UNITED STATES PATENT AND TRADEMARK OFFICE

APPLICATION NO.	FILING DATE	FIRST NAMED INVENTOR	ATTORNEY DOCKET NO.	CONFIRMATION NO.
10/701,515	11/06/2003	Said I. Hakky	MR2493-38	7376

Office Action Summary

DETAILED ACTION

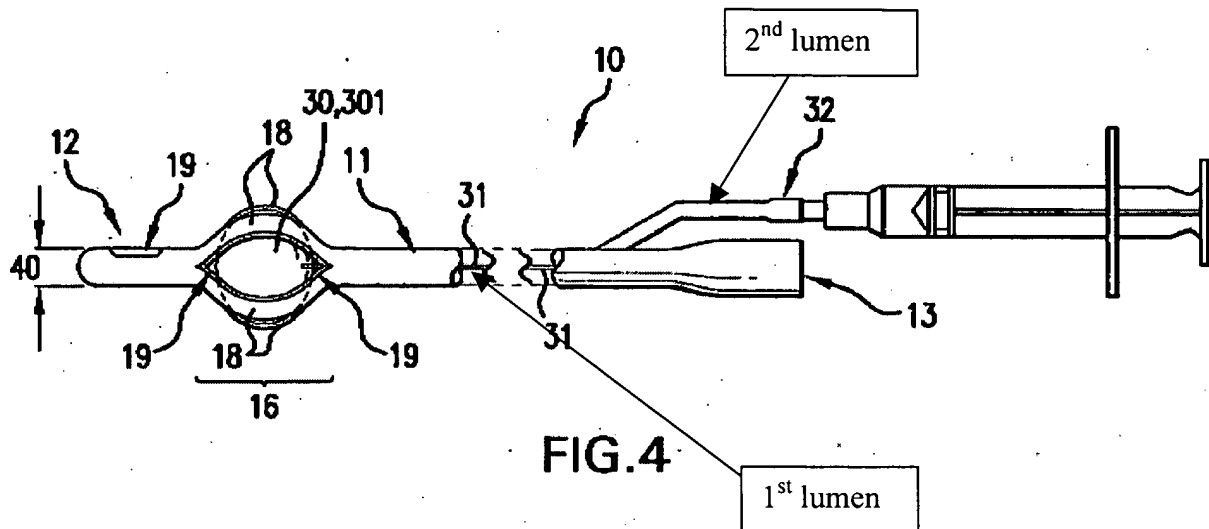
Claim 9 includes the new limitation such that the flexible tube defines “only one single lumen.” This is a negative limitation that defines the invention of what it is not, rather than pointing out the invention. The instant figures show a V-shaped tube having a first and second lumen (see figure 4, *infra*). The instant specification does not expressly teach the absence of a second lumen. Any negative limitation or exclusionary proviso must have basis in the original

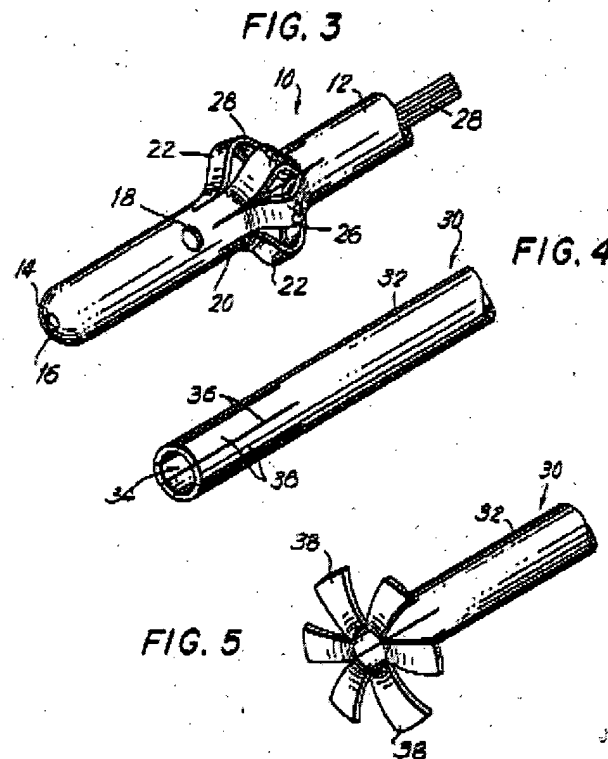
Regarding claim 1, Spinoso teaches a self-retaining urinary drainage catheter system (10), comprising:

(a) a longitudinally extending flexible tube (12) having a predetermined outer diameter, an open distal end and a closed proximal end (14), said flexible tube (12) defining at least one lumen, said closed proximal end (14) having a plurality of longitudinally directed slits (20) formed through a wall of said flexible tube (12) defining a plurality of inherently resilient flexible tube (12) slit portions (22) devoid of separate spring members; and

(b) a reversibly and radially displaceable mechanism (28) being capable of displacing said plurality of flexible tube slit portions (22) of said proximal end (14) to a first configuration (fig. 3) abutting in a non-continuous manner an inner surface of a urinary bladder, said first configuration of flexible tube slit portions (22) having an outer diameter greater than said predetermined diameter of said flexible tube (12) and defining a plurality of drainage apertures (20), and being capable of displacing said plurality of flexible tube slit portions (22) to a second configuration (fig. 1) wherein said plurality of flexible tube slit portions (22) has a diameter substantially equal to said predetermined outer diameter of said flexible tube (12), said plurality of drainage apertures (20) being in direct fluid communication with said lumen, wherein said reversibly and radially displaceable mechanism (28) does not substantially obstruct a lumen of

(c) a wire control device (28) positionally located external and displaced from the longitudinally extending flexible tube (12), said wire control device (28) having a reversible locking mechanism (26, 28) capable of locking said wire control device (28) in a predetermined position (by hand for example)(col. 2, line 46-col. 3, line 37)(see figures 3-5, infra).

Regarding claims 2 and 8, Spinosa teaches that said a wire control device (28) is longitudinally and slidably positioned within a lumen of said longitudinally extending flexible tube (12), said wire control device (28) fixedly secured at a first end (26) to an inner surface of said closed proximal end (12, 14) and having a length greater than a length of said longitudinally extending flexible tube (12) so that a second end of said wire control device (28) protrudes through said open distal end (figures 3-5).

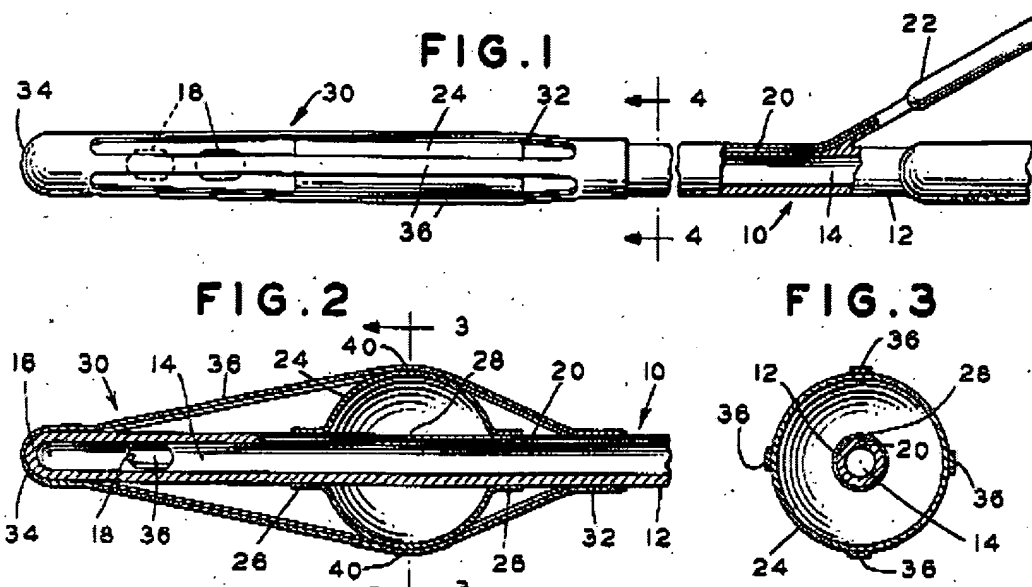
Regarding claim 9, Baskin teaches a self-retaining urinary drainage catheter system (10), comprising:

(a) a longitudinally extending flexible tube (12, 30) having a predetermined outer diameter, an open distal end and a closed proximal end (34), said flexible tube (12, 30) defining

at least one lumen (interior of tubular element (30)), said closed proximal end (34) having a plurality of longitudinally directed slits (36) formed through an outer wall of said flexible tube (12, 30) defining a plurality of flexible tube slit portions (36); and

(b) a reversably inflatable balloon (24) located between said plurality of flexible tube slit portions (36), a microcatheter (20), wherein a fluid may be reversably injected so as to expand said reversably inflatable balloon (24) for reversably and radially displacing said plurality of flexible tube slit portions (36) of said proximal end (34) to a first configuration abutting in a non-continuous manner an inner surface of a urinary bladder, said first configuration of flexible tube slit portions (36) having an outer diameter greater than said predetermined diameter of said flexible tube (12, 30) and defining a plurality of drainage apertures (36), and displacing said plurality of flexible tube slit portions (36) to a second configuration wherein said plurality of flexible tube slit portions (36) has a diameter substantially equal to said predetermined outer diameter of said flexible tube, said plurality of drainage apertures being in direct fluid communication with said lumen wherein said microcatheter (20) does not substantially obstruct a lumen of said catheter (10), and said catheter (10) being of sufficient stiffness to be reversably insertable in a human being without using a stylet (see figures 1 and 2, below).

Regarding claim 10, Baskin teaches a spherical balloon (24)(figure 2).

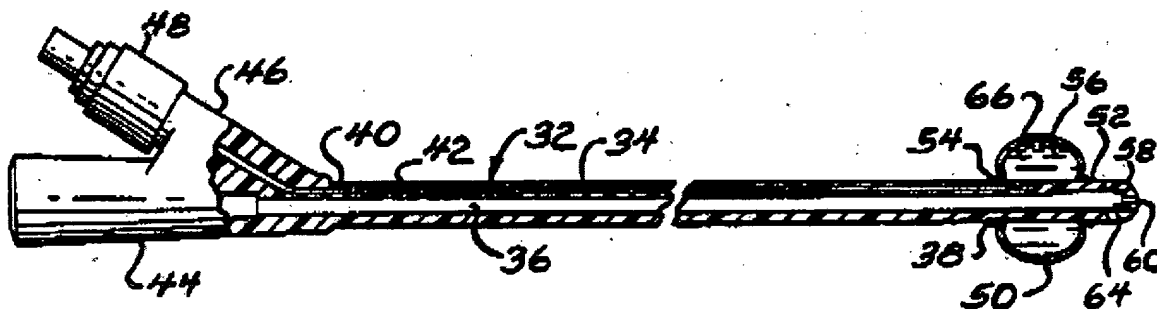
Rosenberg teaches a balloon catheter (32) having a balloon inflation tube (42) that controls fluid flow to the balloon via a valve (48)(see figure 6, below).

Regarding claim 11, Rosenberg teaches an oblong balloon (50)(figure 6).
